City of Madison, Wisconsin

**REPORT OF: URBAN DESIGN COMMISSION**      **PRESENTED:** August 20, 2014

**TITLE:** 202 East Washington Avenue –  
Redevelopment of the “Pahl Tire” Site for  
a 10-Story, 146-150 Room “AC Hotel by  
Marriott” in UDD No. 4. 2<sup>nd</sup> Ald. Dist.  
(33109)

12:24 pm

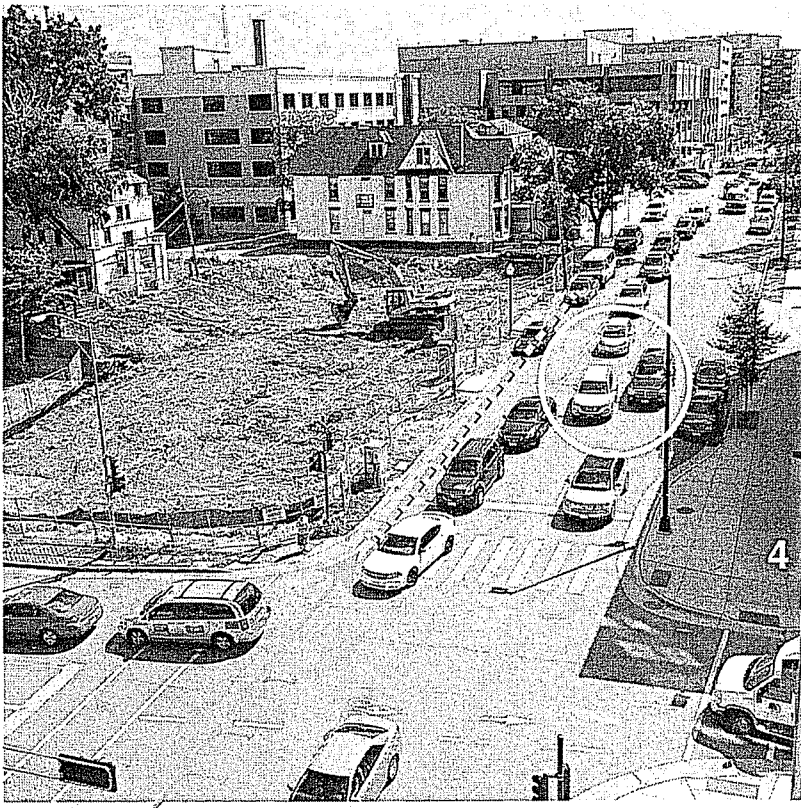
How much of this  
area will remain  
No Parking?
